**PECOS DISTRICT
DRILLING OPERATIONS
CONDITIONS OF APPROVAL**

OPERATOR'S NAME:	Kaiser Francis Oil Company	HOBBS OCD AUG 06 2018 RECEIVED
LEASE NO.:	NMLC063993	
WELL NAME & NO.:	Bell Lake Unit South 403H	
SURFACE HOLE FOOTAGE:	2385'/N & 2200'/W	
BOTTOM HOLE FOOTAGE:	330'/S & 2110'/W	
LOCATION:	Section 1, T.24 S., R.33 E., NMPM	
COUNTY:	Lea County, New Mexico

Figure 1. Cross-sections and plans for typical road sections representative of BLM resource or FS local and higher-class roads.

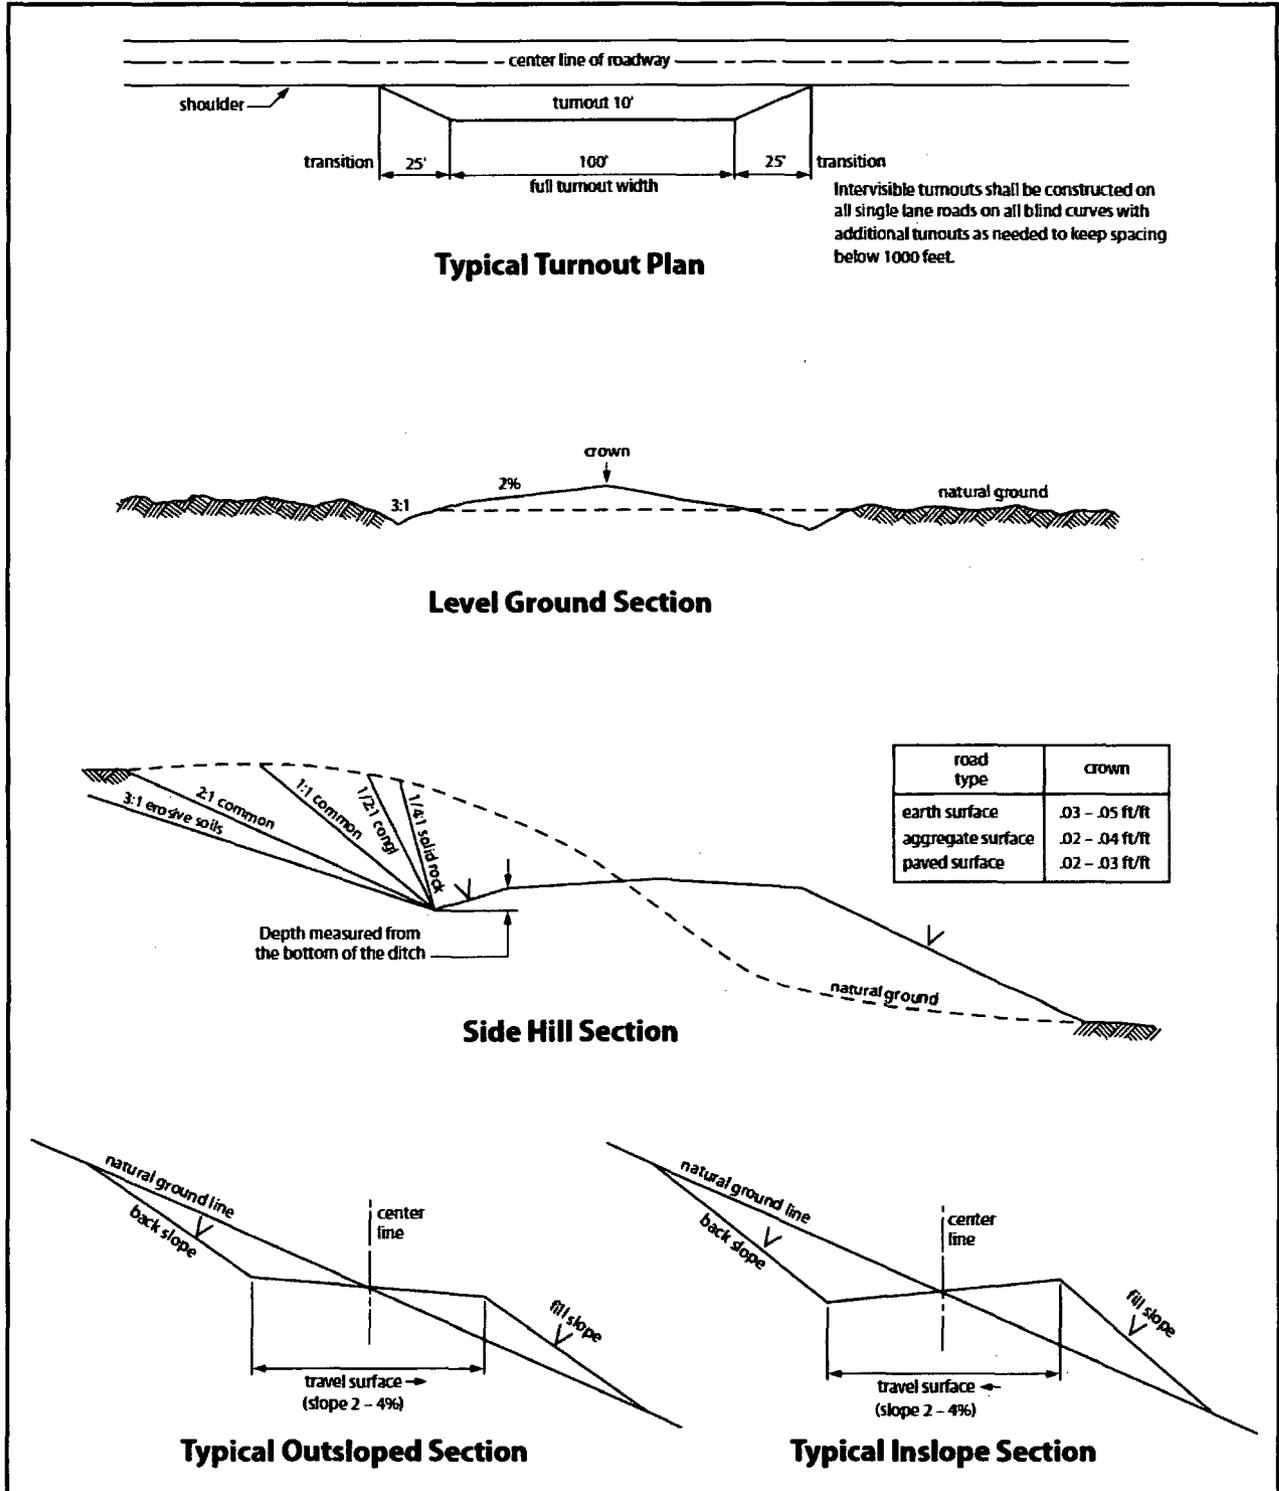
Crowning shall be done on the access road driving surface. The road crown shall have a grade of approximately 2% (i.e., a 1" crown on a 14' wide road). The road shall conform to Figure 1; cross section and plans for typical road construction.
